CPSC Public Meeting on Pool and Spa Drain Covers

April 5, 2011

RE: ASME A112.19.8-07/APSP-16-2010
TECHNICAL DEFECTS IN THE STANDARD THAT LEAD
TO GROSS OVER-RATING OF SUCTION FITTINGS

RELEASE FORCE

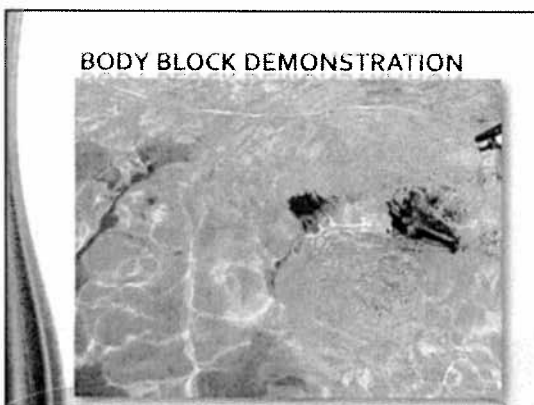
- 12 x 12 flat grate (None VGB Compliant)
- Skin sealed openings
- 20 in. Hg. sustained vacuum
 - 9.8 psi x 97.3 sq. in. open area
- Swimmer held by 954 pounds force
 - The 2007 Standard limit the maximum allowed force to 36 pounds
 - The 2007 standard successfully eliminated the blockable flat and flush mount grates

No-Flow Corrective Procedure Representative Curve –

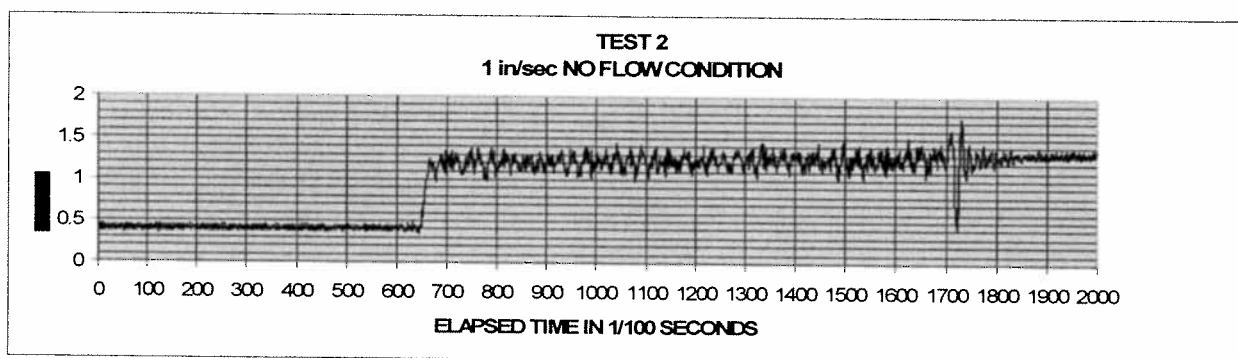
This plot represents the no-flow condition where the skull is simply lifted from full contact with the suction fitting under test at a rate of 1 inch per second vertically to a point approximately 12”-13” above the fitting and represents a measurement of the resultant force over 20 seconds with readings acquired every 1/100 second.

The indicated force present from the skull assembly being hoisted a vertical distance of 12” – 13” at 1 in/sec is approximately 1.25 lbf. This is 0.45 pounds in excess of the saturated-negatively-buoyant skull in the water under a no-flow condition. The relatively steady reading is measured with the skull assembly in vertical motion.

No Flow Standard Procedure Representative Curve –

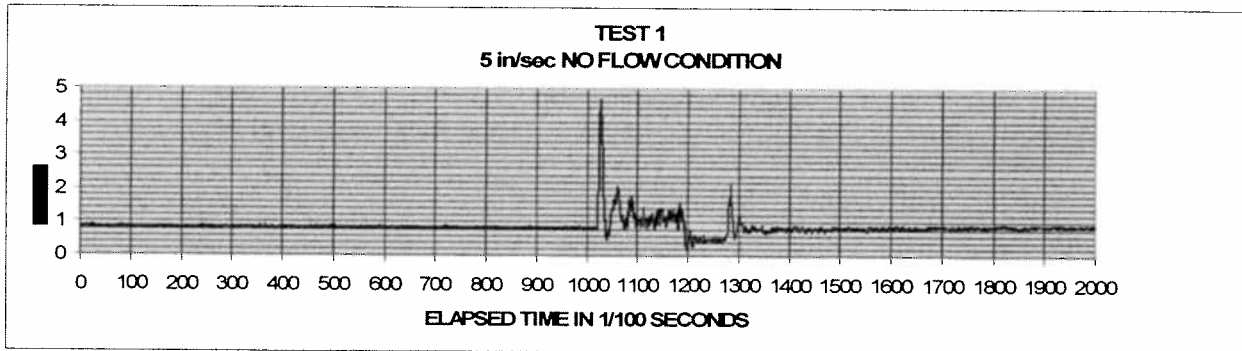
This plot represents the no-flow condition where the skull is simply lifted from full contact with the suction fitting under test at 5 in/sec vertically to a point approximately 12"- 13" above the fitting and is a measurement of the resultant force over 20 seconds with readings acquired every 1/100 second.

The indicated force present from the skull assembly being hoisted a vertical distance of 12"-13" at 5 in/sec approaches 5 pounds in the first micro-seconds and then stabilizes to approximately .80 pounds/force which is the weight of the saturated-negatively- buoyant skull in the water under a no-flow condition. This approaches the failure threshold absent any flow through the suction fitting under test.

No Flow Excess Procedure Representative Curve –

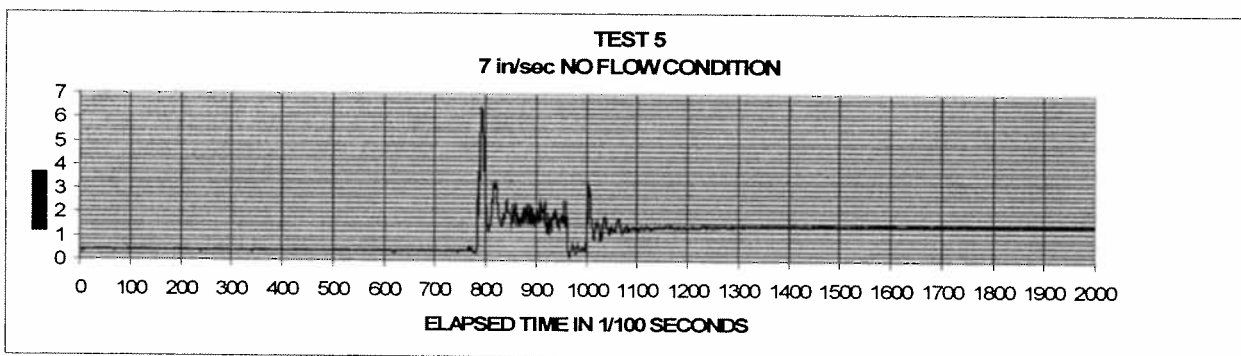
This plot represents the no-flow condition where the skull is just lifted from full contact with the suction fitting under test at 7 in/sec vertically to a point approximately 12"-13" above the fitting and is a measurement of the resultant force over 20 seconds with readings acquired every 1/100 second.

The indicated force present from the skull assembly being hoisted a vertical distance of 12" at 5 in/sec approaches 6.50 pounds in the first micro-seconds and then stabilizes to approximately .80 pounds/force which is the weight of the saturated-negatively-buoyant skull in the water under a no-flow condition. This "false"

Standard Test Procedure Representative Curve @ 125 GPM -

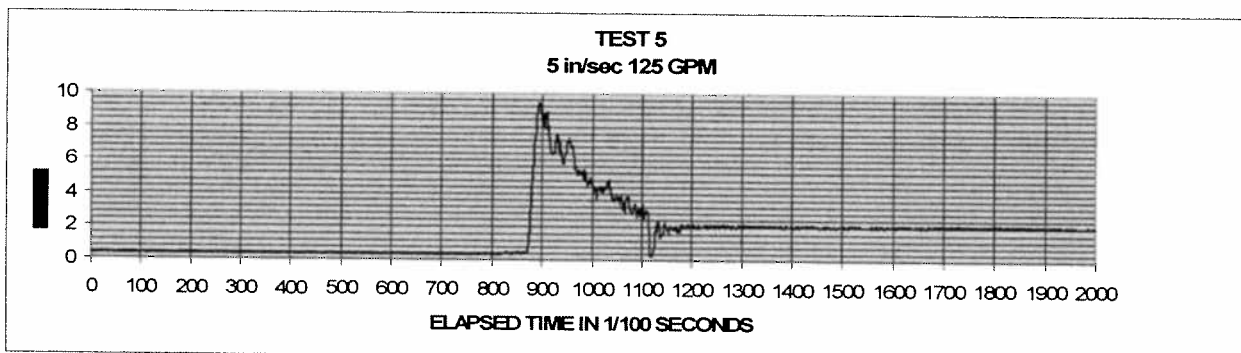
This plot represents the VBG rated test flow standard condition where the skull is just lifted from full contact with the suction fitting under test at 5 in/sec vertically to a point approximately 12"-13" above the fitting and is a measurement of the resultant force over 20 seconds with readings acquired every 1/100 second.

The indicated force present from the skull assembly being hoisted a vertical distance of 12" at 5 in/sec approaches 10.0 pounds force. This would constitute a failure under the standard at the test flow of 125 gpm.

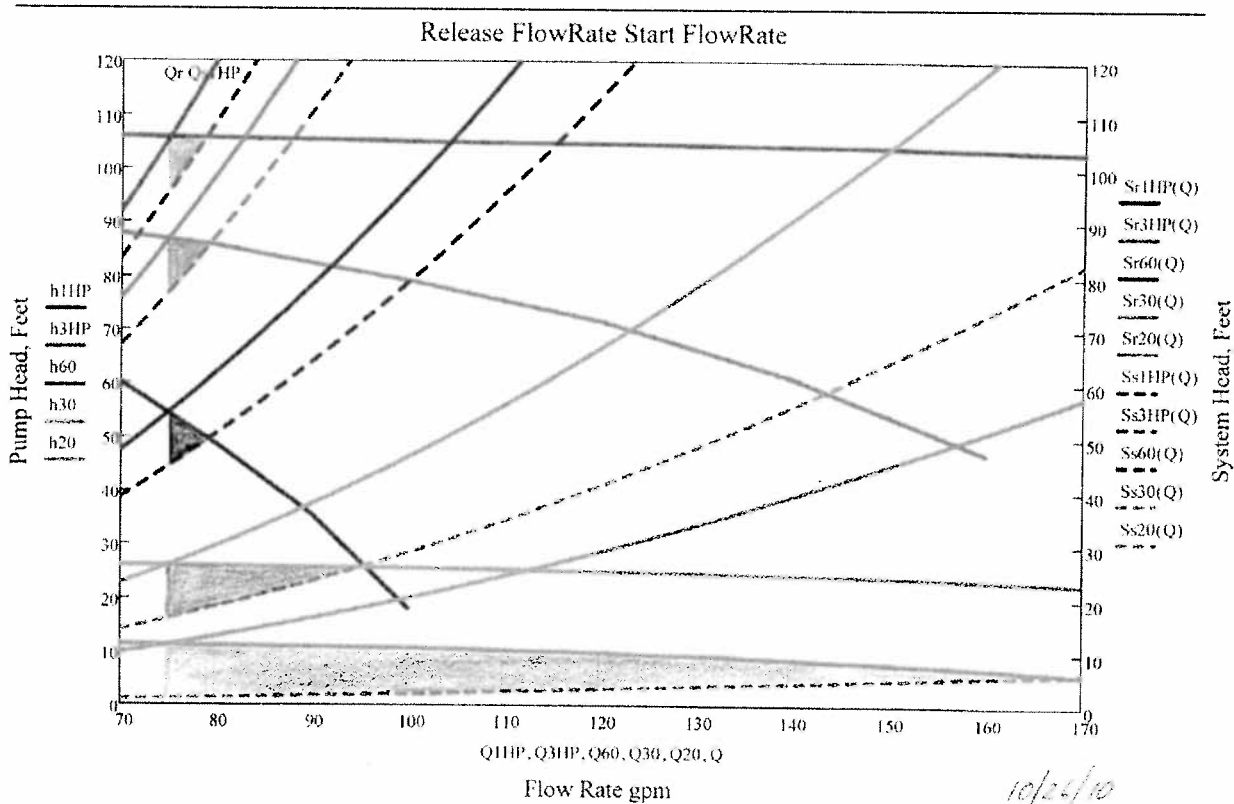
The subject suction fitting was then tested using the stand above. The flow was preset at 70gpm/30 Hz and the sustained vacuum level was verified to be at least 25 in/HG upon complete suction fitting blockage. The skull assembly was the lowered until the skull rested on the suction fitting under test. The skull was permitted to remain in contact without releasing the five pound counter weight for 90 seconds. The counter weights were carefully released so that the full five pounds was acting on the skull assembly. The flow rate at the point the skull assembly released was recorded at between 39 and 41 gpm over numerous trials.

If we were to assign the most conservative maximum flow rating for the subject fitting it would be 45 gpm based upon the test data. This is considerably less than the VGB-rated flow of 100 gpm.

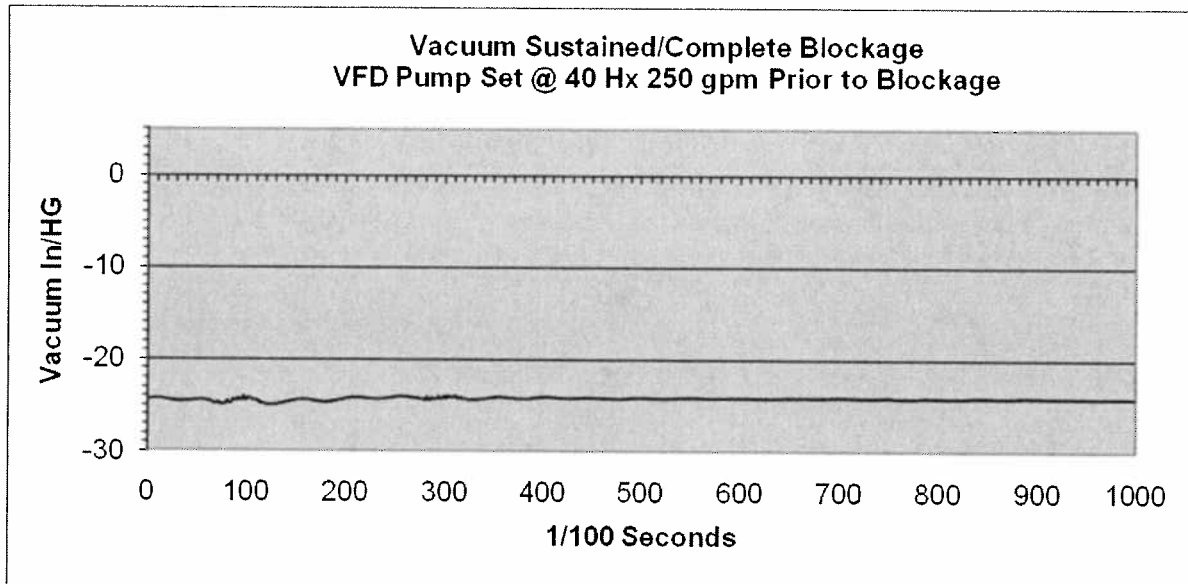
The chart below represents the resultant vacuum force reading when the 10 horsepower VFD pump is preset to flow at 250 gpm/40 Hz through a 2" SCH 40 pipe and then blocked.

The recorded sustained vacuum level acquired after the blockage has occurred is approximately 25 in/HG. 25 in/HG is a high vacuum reading. 25 in/HG sustained vacuum would produce a hold-down force of 525 on an 8 inch nominal sump having an area of 42.72 in².

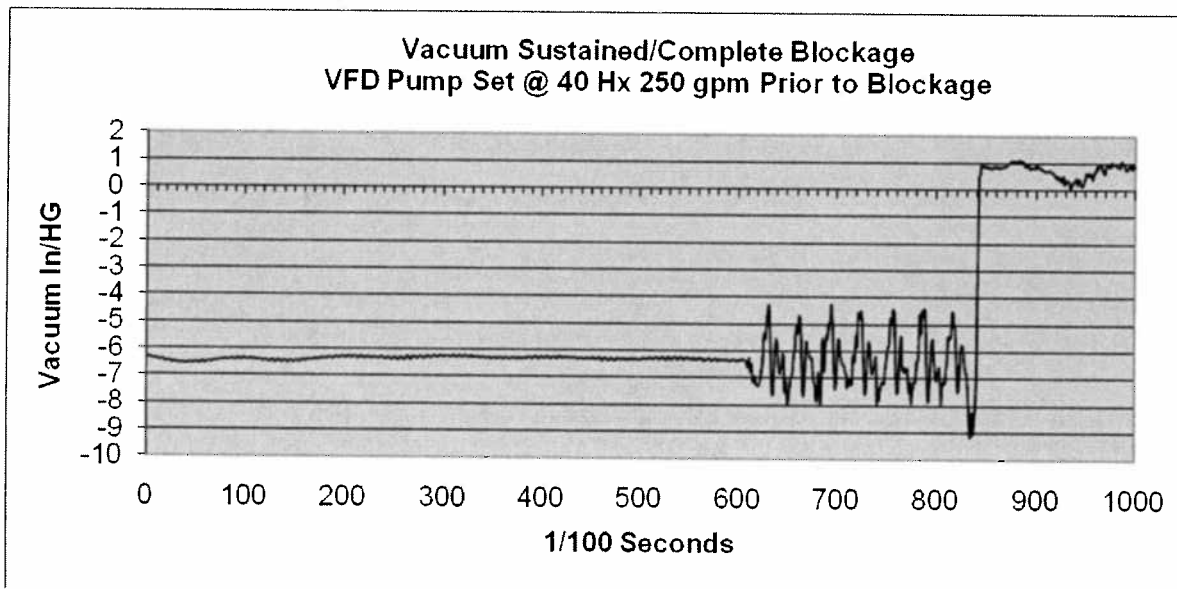
The chart below represents the resultant vacuum force reading when the 10 horsepower pump is preset to flow at 70gpm/15Hz through a 2" SCH 40 pipe and then blocked.

The recorded sustained vacuum level acquired after the blockage has occurred is approximately 6.5 in/HG. 6.5 in/HG is a relatively low vacuum reading. This level would produce a hold-down force of 136 on an 8 inch nominal sump having an area of 42.72 in².
